DUKE POWER COMPANY

Re: Catawba Nuclear Station
Docket Nos. 50-413 and 50-414

CATAWBA NUCLEAR STATION
ENVIRONMENTAL QUALIFICATION OF ELECTRICAL EQUIPMENT
RESPONSE TO NUREG 0588

ENVIRONMENTAL QUALIFICATION OF ELECTRICAL EQUIPMENT RESPONSE TO NRC EQ AUDIT ITEMS

FIGURE 1

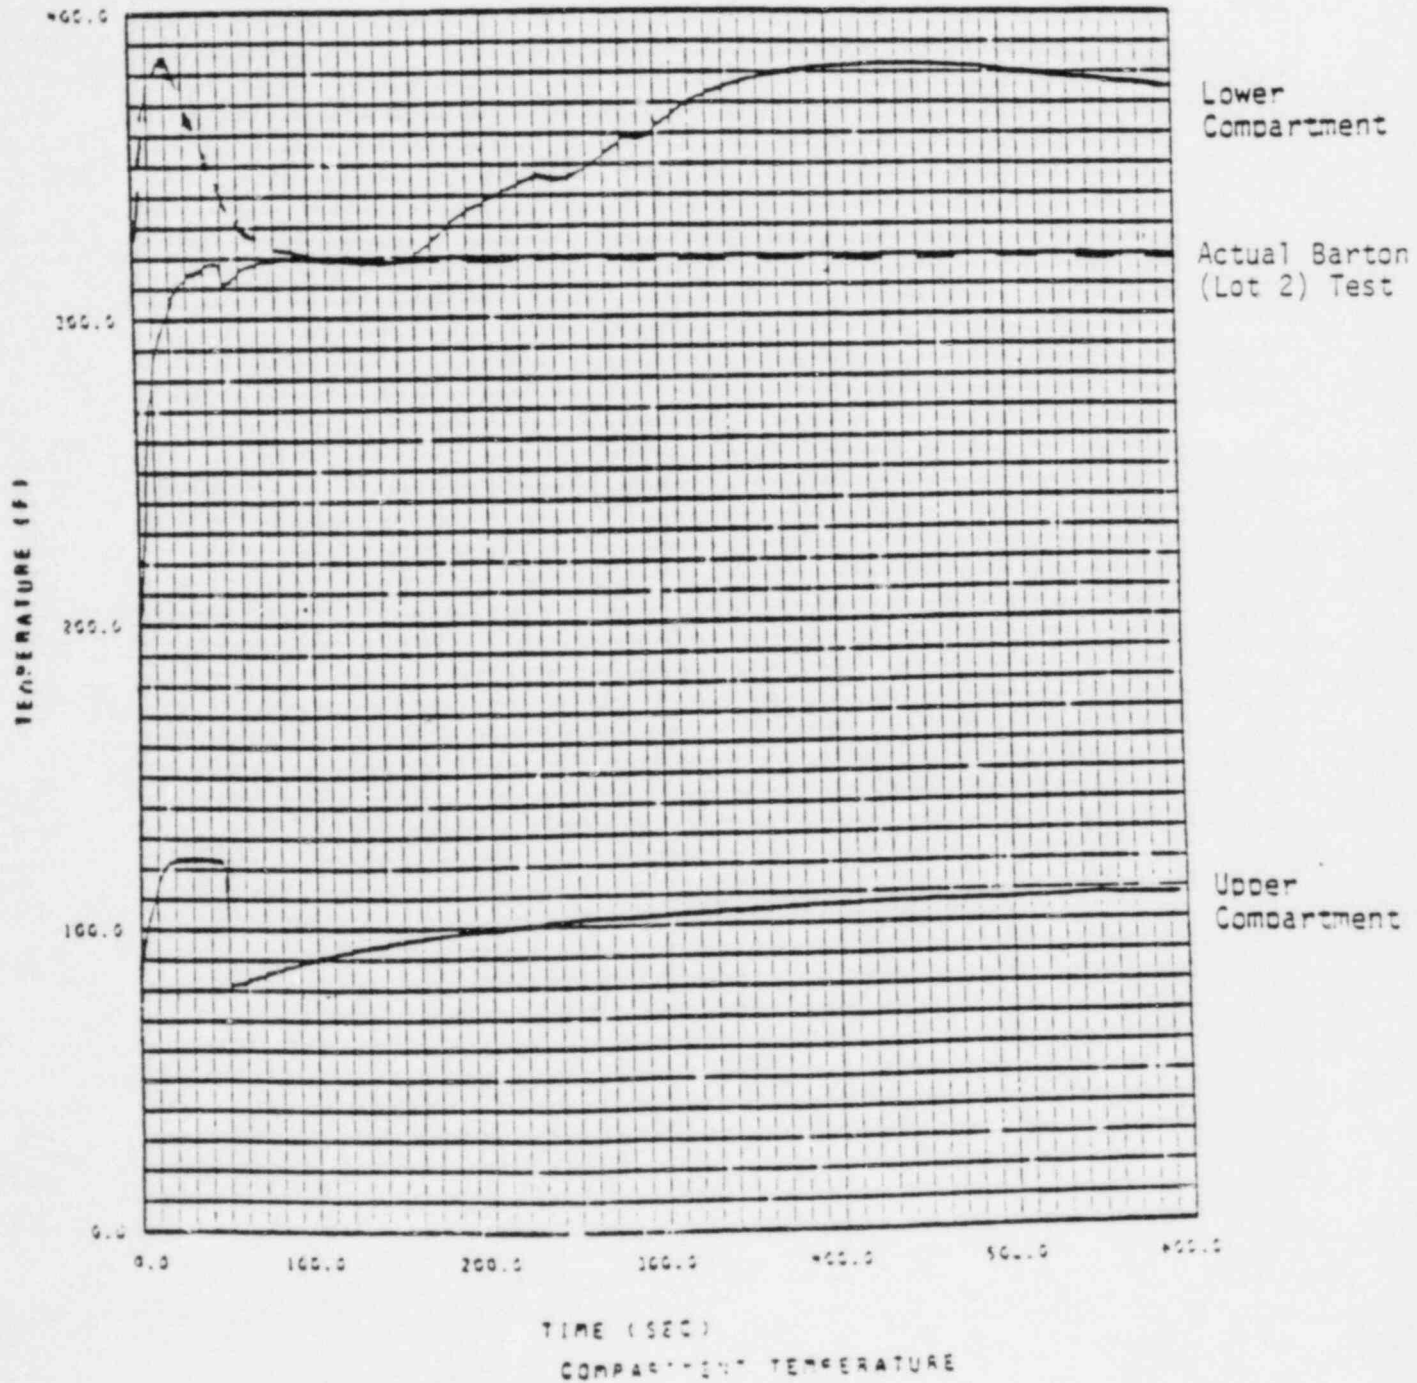
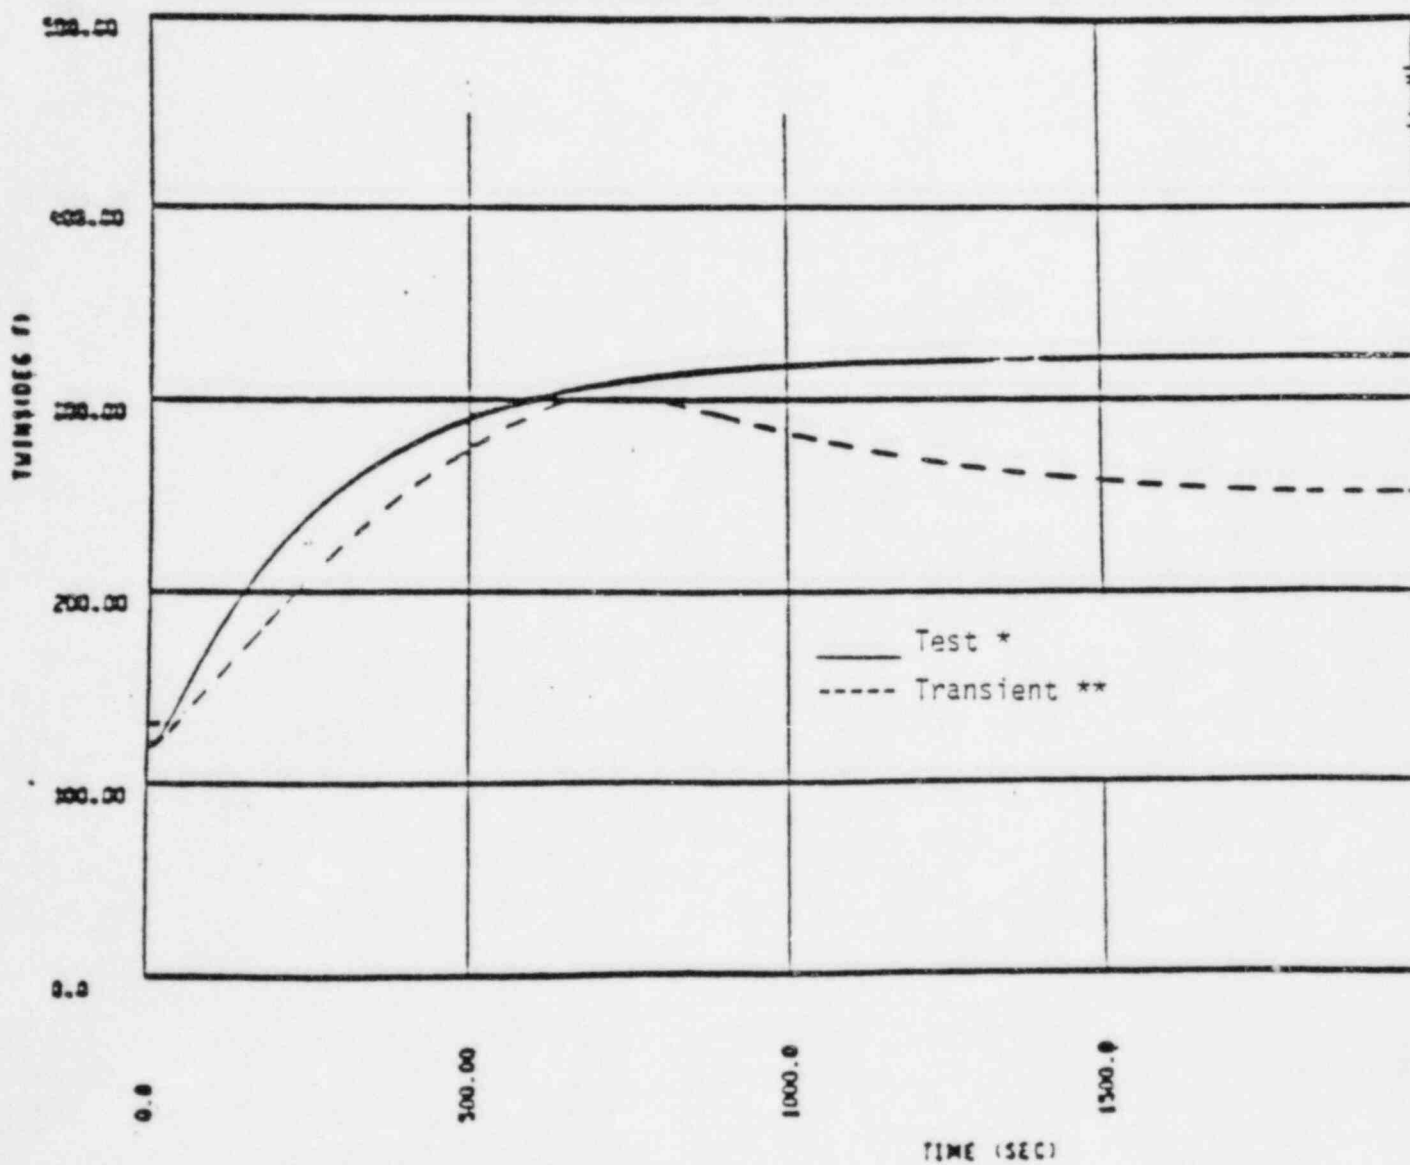
During the review of the Barton transmitter qualification report (WCAP 9885) the NRC requested additional information concerning the temperature profile of the qualification test. Specifically, the FSAR peak postulated accident temperature has a time duration of approximately 10 minutes versus the qualification test peak temperature duration of approximately 5 minutes.

Westinghouse has performed a thermal analysis of the transmitter which demonstrates that for a temperature/duration in excess of the Catawba accident environment, the internal transmitter temperature does not exceed the temperature experienced during the qualification test. This analysis coupled with the transmitter qualification program provides adequate assurance of qualification. Documentation necessary to support this thermal analysis is on file and available for audit at Duke Power Company.

The dashed curve of Figure 1 is the actual Barton test profile. The solid curve of Figure 2 is the calculated temperature inside the transmitter during the actual test analyzed out to 10 minutes. The solid curve of Figure 1 is the lower compartment postulated accident profile which envelopes the Catawba accident profile. The dashed curve of Figure 2 is the calculated temperature inside the transmitter during the postulated accident represented by the solid curve of Figure 1. These curves demonstrate that for a temperature/duration in excess of the Catawba accident environment, the internal transmitter temperature does not exceed the transmitter temperature experienced during the qualification test.
